**TO:** Dr. Jesse Bacon, Superintendent  
**FROM:** Danny Clemens, Director of Facilities  
**Date:** February 21, 2024  
**RE:** Baseball/Softball Fields - Change Order 14 - All High Schools - CMU Curb Deduct - Roof Insulation Add **DC**

**PROJECT:** *(Name and address)*  
BCPS - Phase II Athletics - Bid Package  
No. 1 - Baseball and Softball  
Bullitt County, Kentucky

**CHANGE ORDER INFORMATION:**  
Change Order Number: 014

## Change Order Request 31 - PCO #59 - Roofing Detail Added Insulation

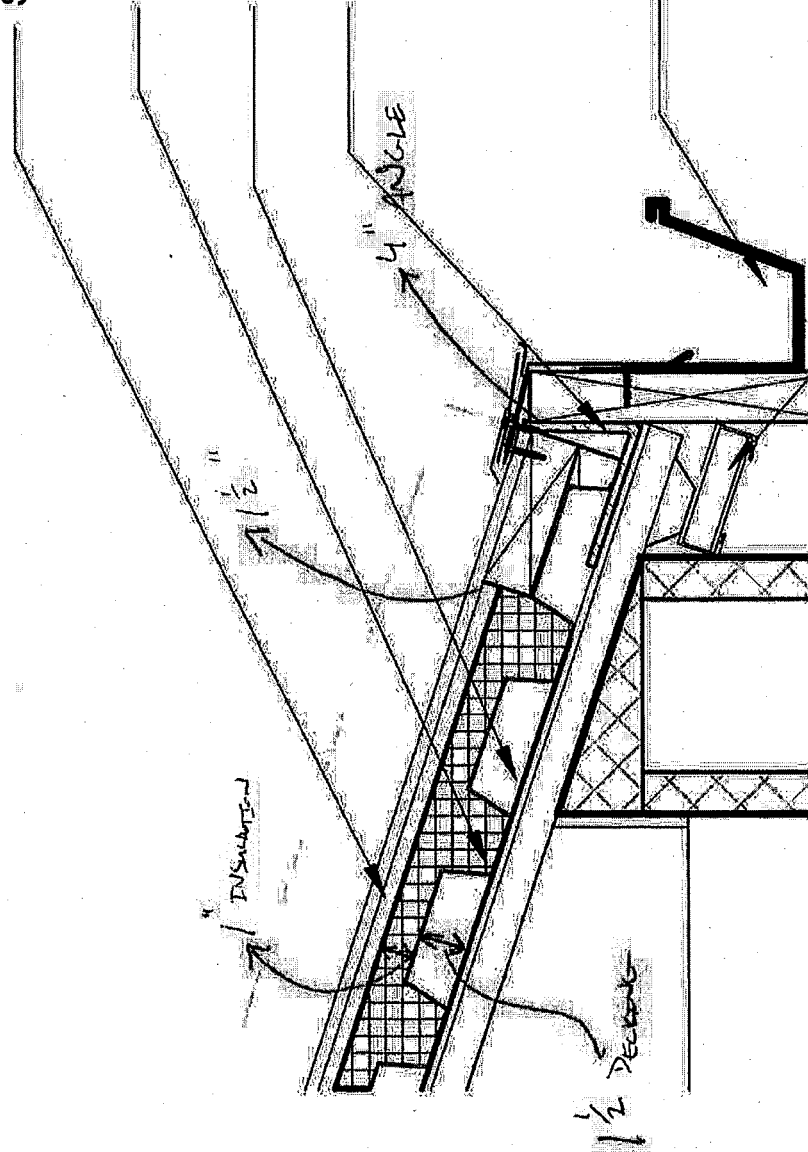
Scope - Subcontractor	Description	QBS
		\$13,500.00
o Roofing - Deerpark ==> Add 2.5" insulation to match height of steel per RFI #44 ==> \$13,500.00

FURNISH & INSTALL 2.5" ISO ON ENTIRE ROOF SYSTEM TO MATCH THE HIGHT OF THE STEELE  
ANGLE AT THE EAVE, TO ALLOW A SMOOTH TRANSITION FOR THE STANDING SEAM METAL  
ROOF SYSTEM.

Refer to Drawing A1.63 - Detail #12

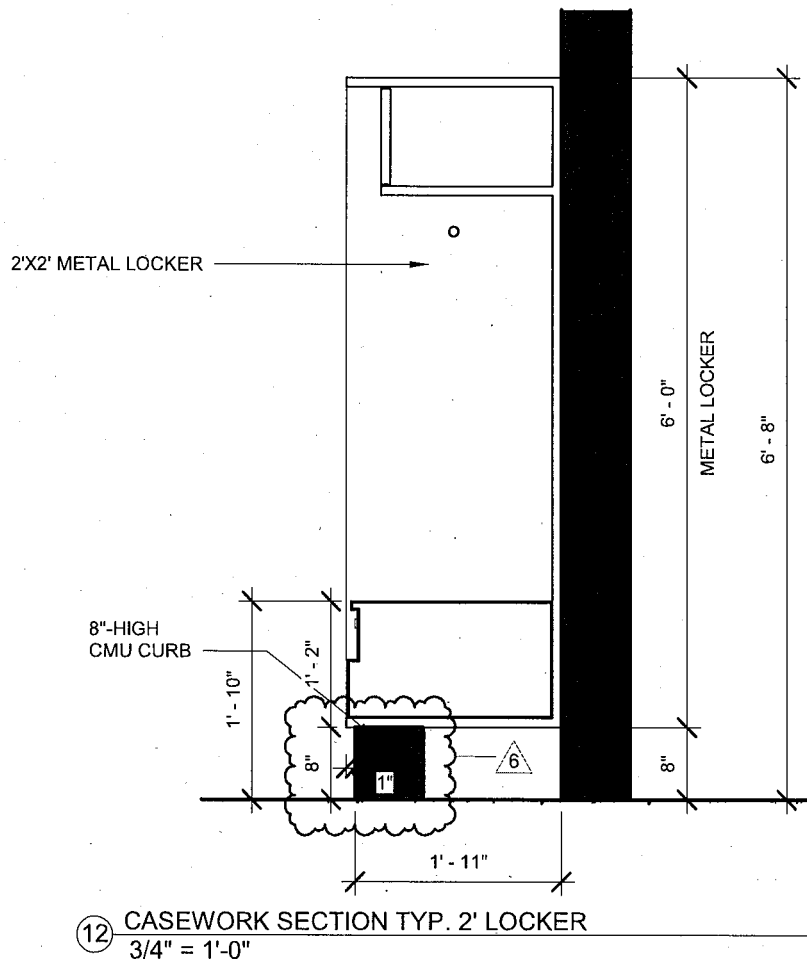
1. See revised CMU Curb base at Metal Lockers - height revised from 12" to 8" in height.
